## BOARD OF WATER SUPPLY

Subject: Honolulu Board of Water Supply (BWS) Comments on the Red Hill  
Administrative Order on Consent (AOC) Statement of Work (SOW)  
Sections 6 and 7 Groundwater Modeling Working Group Meeting No. 9  
held March 16, 2018

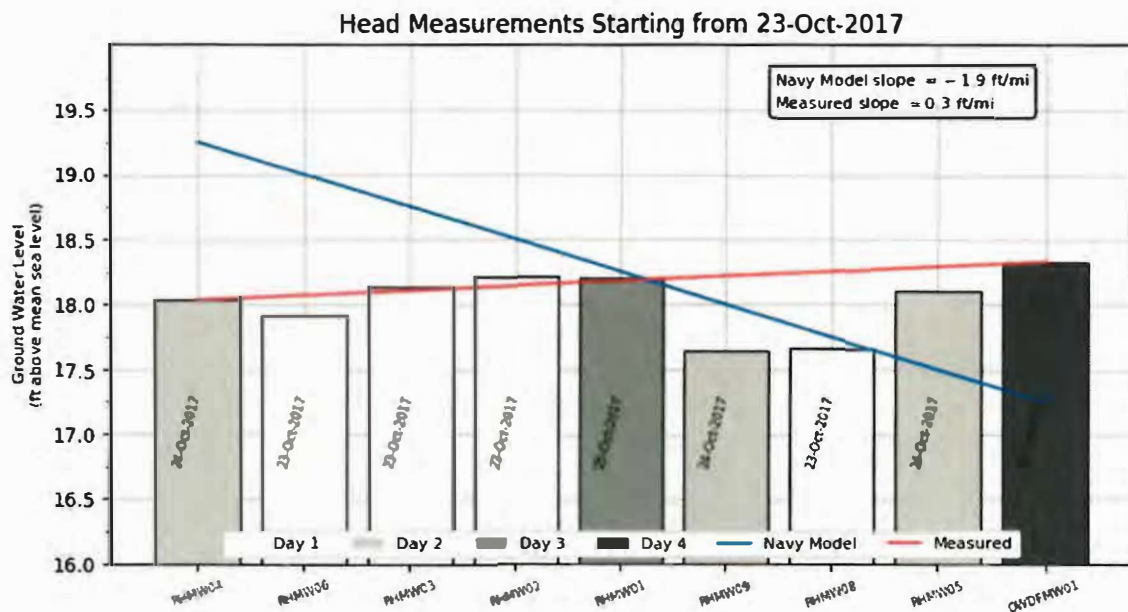
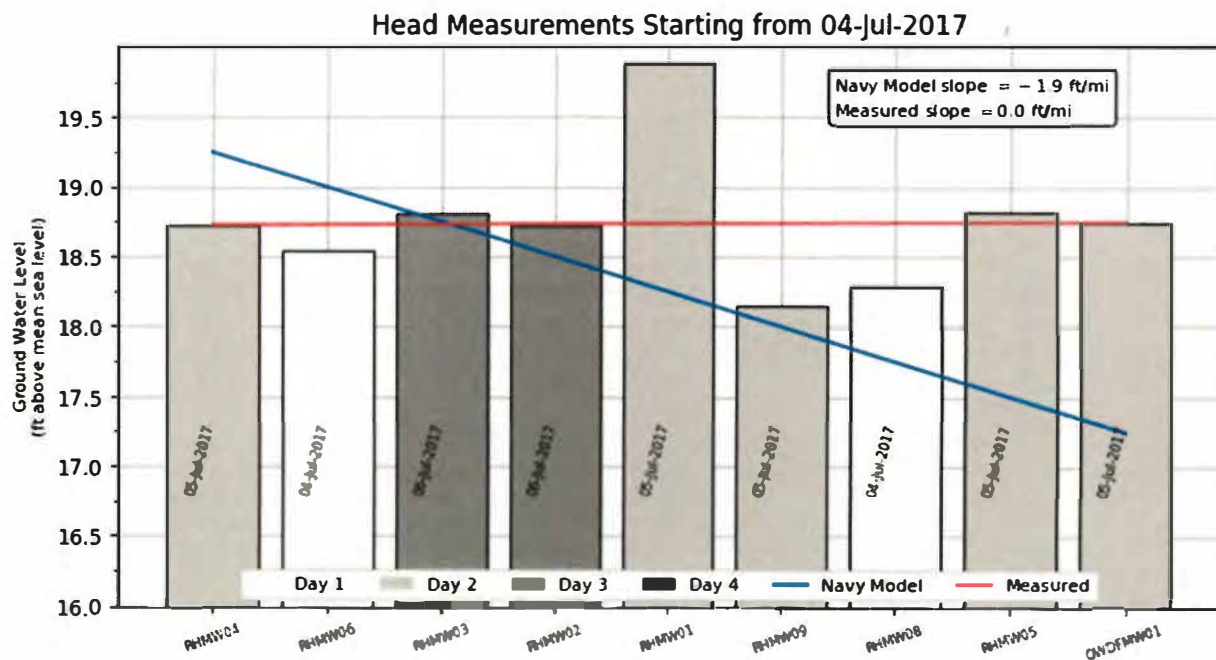
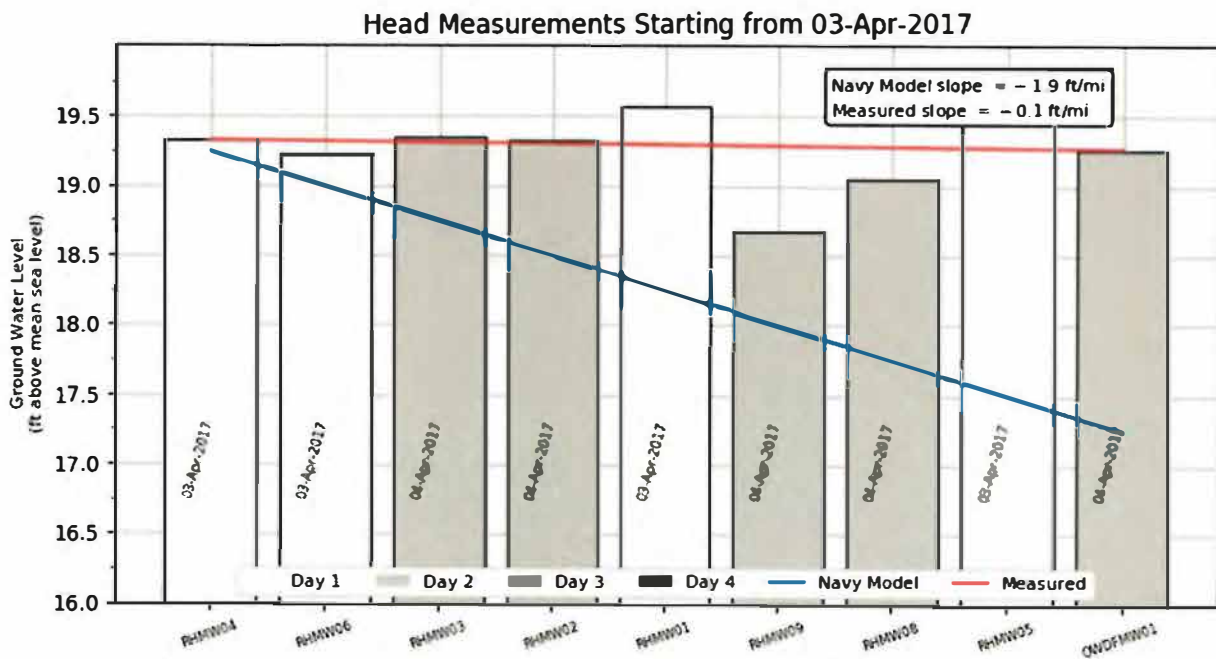
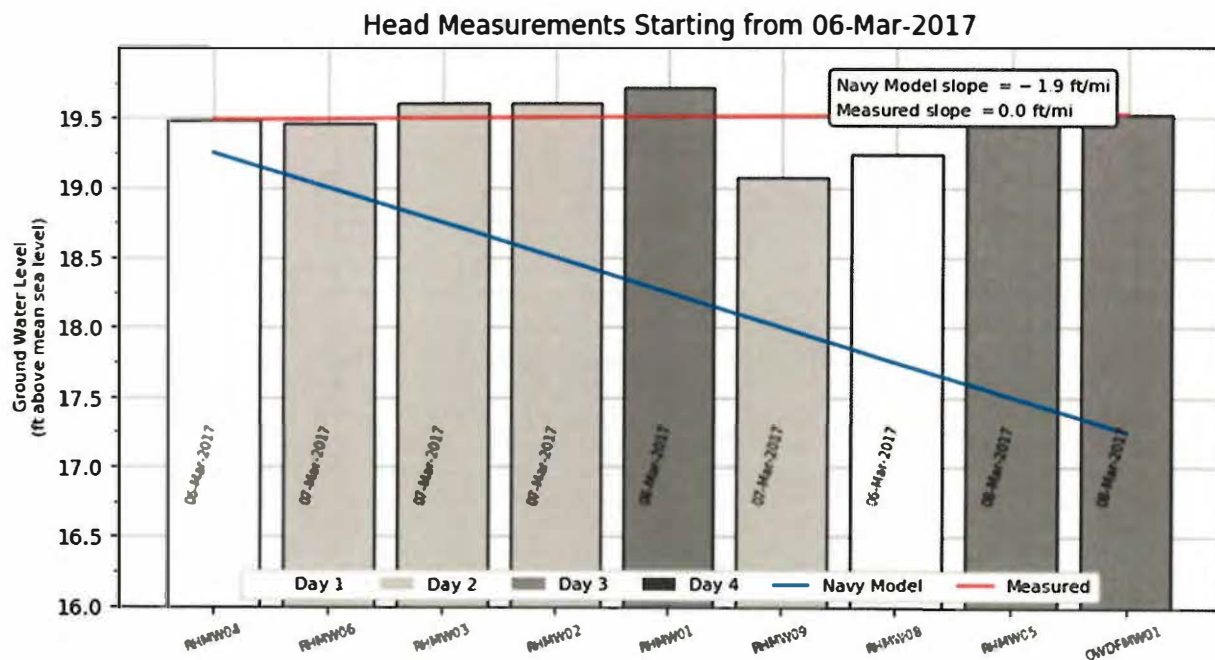
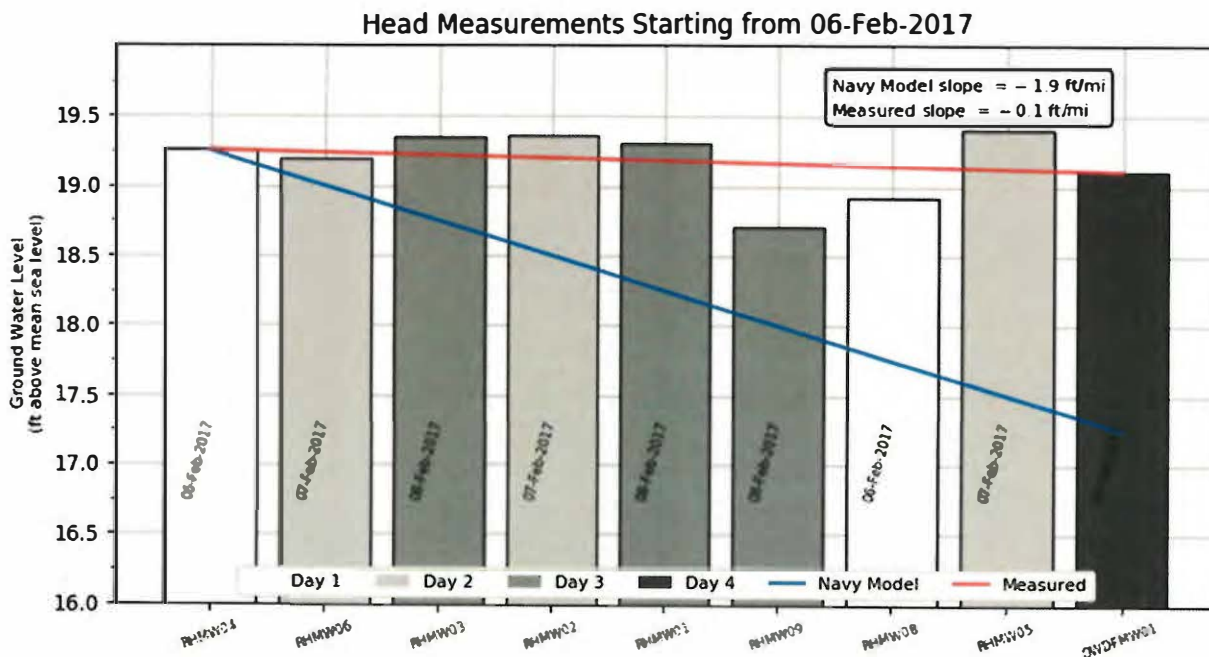
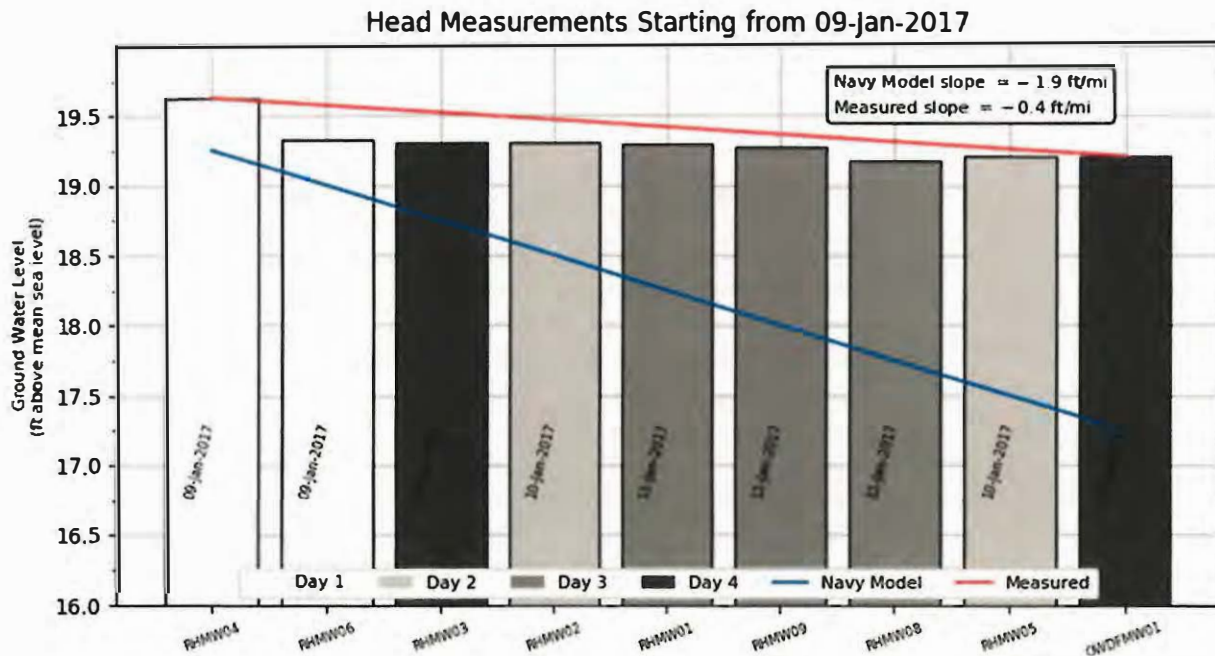
Comparison of the Navy's predicted 2017 steady state groundwater levels with levels observed at different 2017 dates shows the same alarming disparity for all of the time periods examined. We estimated groundwater levels using depth to groundwater data presented in Appendix A Table A.4-1 of DON (2018a) and corrected elevations for tops of well casings presented in Table 2 of DON (2018b) to create the plots below. Whether for October, July, April, March, February, or January 2017 (Figures 1 to 6 below), the observed levels at monitoring wells RHMW04 and OWDFMW01 consistently show

negligible or very small differences even though there may have been one to four days between measurements. The BWS also examined the data for November 18, 2016 when all wells were measured on the same day and found similar results.

The BWS has little to no confidence in the interim groundwater flow model. The Navy's predicted 2017 steady state groundwater levels do not match any observed levels made during six different months in 2017 at the monitoring wells on the Red Hill Facility. Nor do the model's predictions match the Navy's 2017 steady state observed levels for these same wells. Furthermore, the Navy's measurements of groundwater levels at Red Hill Shaft are 0.8 to 0.9 feet (ft.) higher than the observed level at monitoring well RHMW02, where the greatest contamination has been measured, for five of the six different 2017 time-periods. This contradicts the Navy's modeling results that pumping at Red Hill Shaft will maintain a large capture zone across the entire facility. The BWS asks how can the Regulatory Agencies or the SMEs depend on the Navy's interim model to defensibly inform the TUA selection process when the information available throughout 2017 contradicts both the model's predicted 2017 groundwater levels and its predicted large capture zone across the Red Hill Facility from pumping at Red Hill Shaft?
